**RE: HIDDEN HILLS SOLAR ELECTRIC GENERATING SYSTEM
APPLICATION FOR CERTIFICATION 11-AFC-02**

SUPPLEMENTAL

COMMENTS & ANALYSIS

SUBMITTED BY C.R. MACDONALD
JULY 2012

WATER SUPPLY - FIGURE 22
Hidden Hills Solar Electric Generating System (HHSEGS)

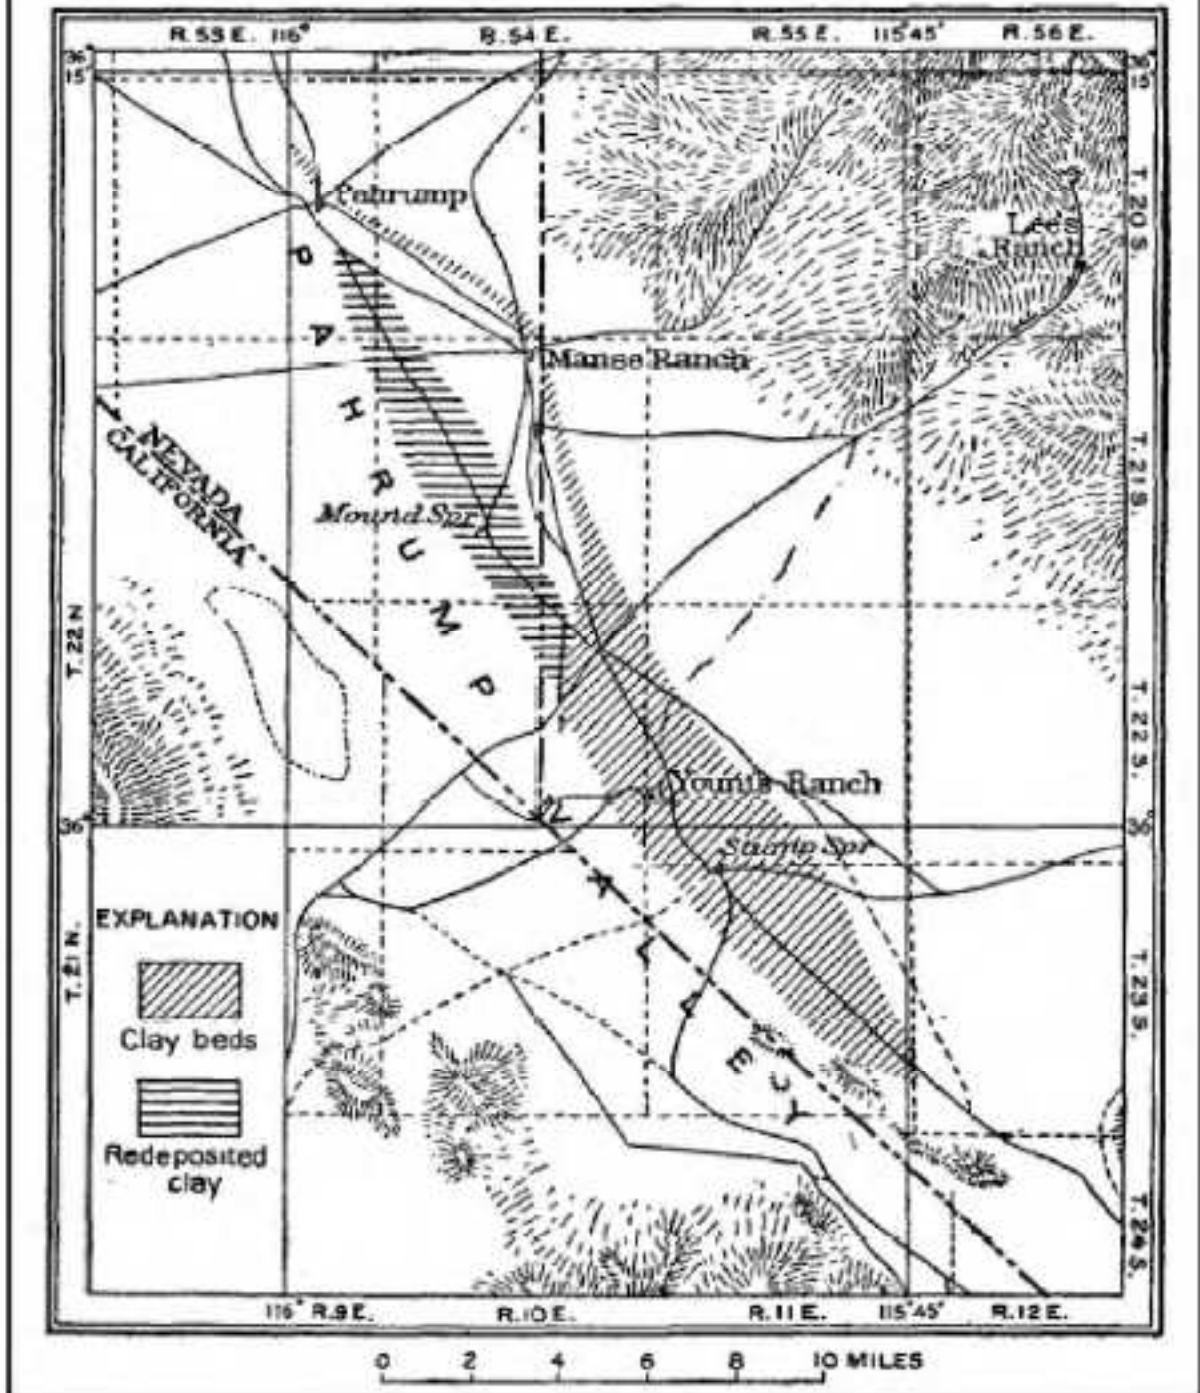
Additionally, the Preliminary Geotechnical Report compiled by the applicant in 2011 contained the most current data and evaluations available of soil properties related to the proposed project sites suitability. All of its key findings and warnings were ignored by the CEC Staff in the Preliminary Staff Assessment.

Source: HHSEGS Preliminary Staff Assessment, Soils and Surface Waters, Figure 3, pg. 611.

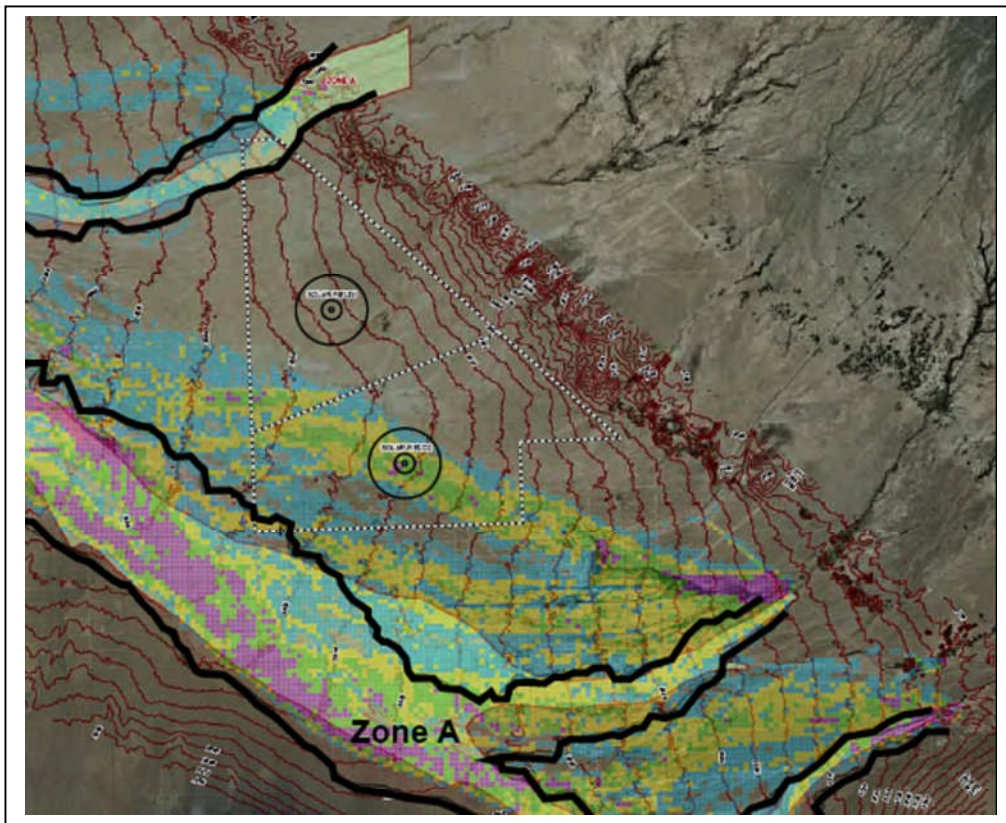
“Two areas, located at the north tip of the site and the southwest corner of the site (see Soils & Surface Water Figure 3) have been mapped by FEMA as Zone A, which means 100-year flood zone with no base flood levels determined. These are considered approximate flood zones.”⁽¹⁾ [Emphasis added.]

“FEMA maps do not cover all floodplains. The applicant completed a Preconstruction Hydrology Analysis that modeled onsite peak flows, runoff volumes, maximum velocities and maximum depths during more frequently occurring storm events. Soils & Surface Water Table 5 presents the estimated peak flows leaving the site calculated from crosssections located along the west border (as shown in Soils & Surface Water Figure 4). The majority of runoff flows through the southern portion of the site due to offsite flows originating from the east.”⁽¹⁾ [Emphasis added.]

“Furthermore, although the retention area would cause substantial onsite flooding, the inundated area (as shown in Soils & Surface Water Figure 7) would not extend past the proposed site’s borders to flood offsite areas east of the project site. Staff agrees with the applicant that HHSEGS would avoid significant adverse impacts which could result from offsite flooding.”⁽²⁾ [Emphasis added.]

Map Source: Hidden Hills SEGS, Supplemental Data Response, Set 2, TN-64558, Figure 1. pp. 318 (pdf. file)

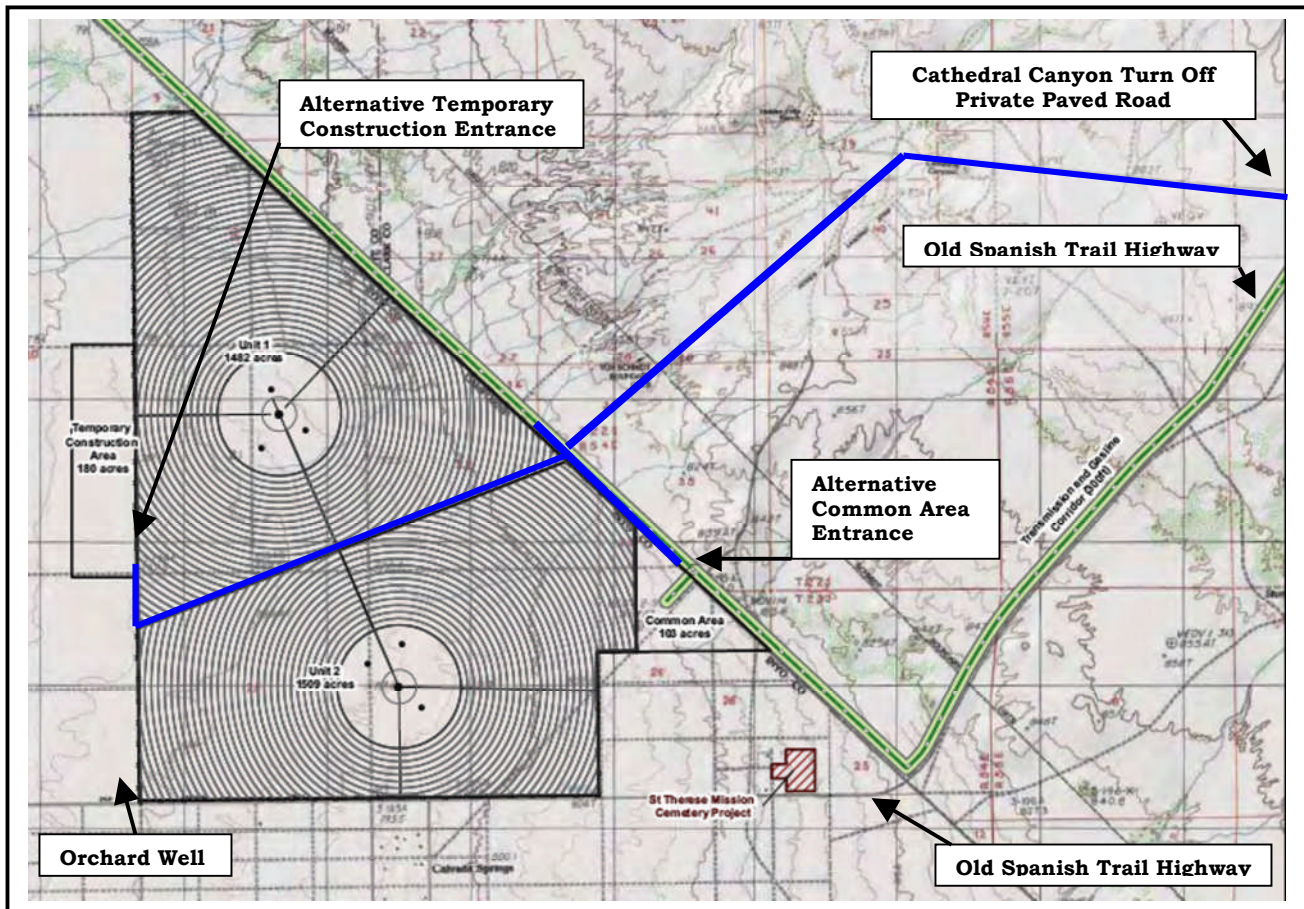
**TRANSMISSION SYSTEM/GAS PIPELINE
ALTERNATIVE ROUTE**

Instead of the transmission system and gas pipeline entering the site from the Old Spanish Trail Highway on the California side of the border, entry could also be obtained on the Nevada side of the Old Spanish Trail Highway at the juncture of a private road formerly used to access Cathedral Canyon. This road (shown right) is located 5.5 miles from Orchard Well and while not complete, could be developed to lead directly into the project site.

The road is owned and controlled by the same parties who are leasing the land to applicant and therefore, they have complete control to authorize the construction and maintenance of a private road to access the site.
